Access Compliance Report

Public Rights-of-Way

(Curb Ramps)

Intersection ID: 51310	Main Street: I-485_RA	Cross Street: W_W_T_HARRIS_BV	Location: E
ADA ID: 968ECAE9E399	Ramp Type: BlendTrans2	Initial Pass/Fail: Fail	Overall Compliance: No
		Severity Score: 8.75

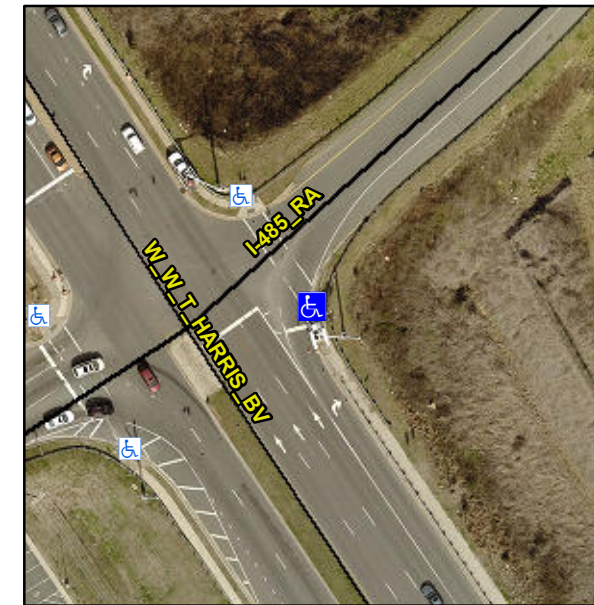
Not Found, R304.5.1

Compliance	Description	Data	Compliance	Description	Data
N/A	Ramp Length (in)	59.0	Yes	BlendTrans Slope (%)	2.1
No	Ramp Width (in)	46.0	Yes	BlendTrans XSlope (%)	0.6
N/A	Flare Type LT	N/A	N/A	Flare Type RT	N/A
N/A	Flare Slope LT (%)	N/A	N/A	Flare Slope RT (%)	N/A
N/A	Flare Traversable LT?	N/A	N/A	Flare Traversable RT?	N/A
N/A	Landing Length (in)	N/A	N/A	DWS Provided?	N/A
N/A	Landing Width (in)	N/A	N/A	DWS Contrast?	N/A
N/A	Landing Slope (%)	N/A	N/A	DWS Length (in)	N/A
N/A	Landing X Slope (%)	N/A	N/A	DWS Full Width?	N/A
N/A	Landing Curb? (Y/N)	N/A	N/A	DWS Offset (in)	N/A
N/A	Shared Landing?	N/A			
N/A	Gutter Ponding?	N/A	N/A	Gutter Slope (%)	N/A
N/A	Gutter Lip Ht (in)	N/A	N/A	Gutter X Slope (%)	N/A
N/A	Painted X Walk1?	Yes	N/A	Painted X Walk2?	N/A
	X Walk 1 Direction	To NW		X Walk 2 Direction	N/A
	X Walk 1 Width (in)	113.0		X Walk 2 Width (in)	N/A
	X Walk 1 Slope (%)	0.7		X Walk 2 Slope (%)	N/A
	X Walk 1 X Slope (%)	2.3		X Walk 2 X Slope (%)	N/A

N/A	Ramp inside XWalk1?	Yes	N/A	Ramp inside XWalk2?	N/A
	Road Slope (%)	2.3		Clear Space?	N/A
	Road X Slope (%)	0.7	N/A	Clear Space to XWalk (in)	N/A
N/A	Any Obstructions?	N/A	N/A	Storm Grate/Utility Hazard?	N/A
	Obstruction Type			Storm Grate/Utility Type	
		N/A			N/A
			Yes	Surface Condition? (G/P)	Good
			No	Curb Slope (%)	9.8

Remove & Replace Curb Ramp With Two New Directional Ramps or Equivalent.
